TRANS/WP.29/916
17 April 2003

World Forum for Harmonization of Vehicle Regulations (WP.29)

DRAFT SUPPLEMENT 15 TO REGULATION No. 54

(Pneumatic tyres for commercial vehicles)

Annex 3, amend to read:

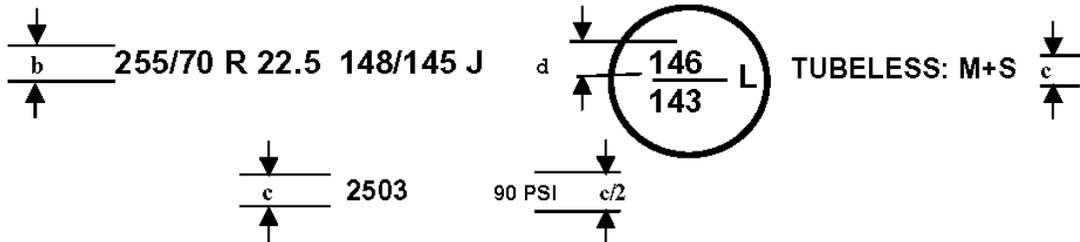
MINIMUM HEIGHTS OF MARKINGS (mm)	
	Tyres of nominal rim diameter < 508mm (Code 20) or of nominal section width ≤ 235mm (Code 9)	Tyres of nominal rim diameter ≥ 508mm (Code 20) or of nominal section width > 235mm (Code 9)
B	6	9
C	4	
D	6

1. These markings, given as an example, define a pneumatic tyre:

Having a nominal section width of 255;

Having a nominal aspect ratio of 70;

Of radial-ply structure (R);

Having a nominal rim diameter of 572 mm, for which the symbol is 22.5;

Having load capacities of 3,150 kg when single and 2,900 kg when twinned (dual), corresponding respectively to the load indices 148 and 145 shown in annex 4 to this Regulation;

Having a reference speed of 100 km/h corresponding to speed category symbol: J

Classified in the category of use Snow: M+S

Able to be used additionally at 120 km/h (speed category symbol L) with a load capacity of 3,000 kg when single and 2,725 kg when twinned (dual), corresponding respectively to the load indices 145 and 143 shown in annex 4 to this Regulation

Capable of being fitted without inner tube: "TUBELESS"

Manufactured during the twenty-fifth week of the year 2003, and

Requiring to be inflated to 620 kPa for load/speed endurance tests, for which the PSI symbol is 90.
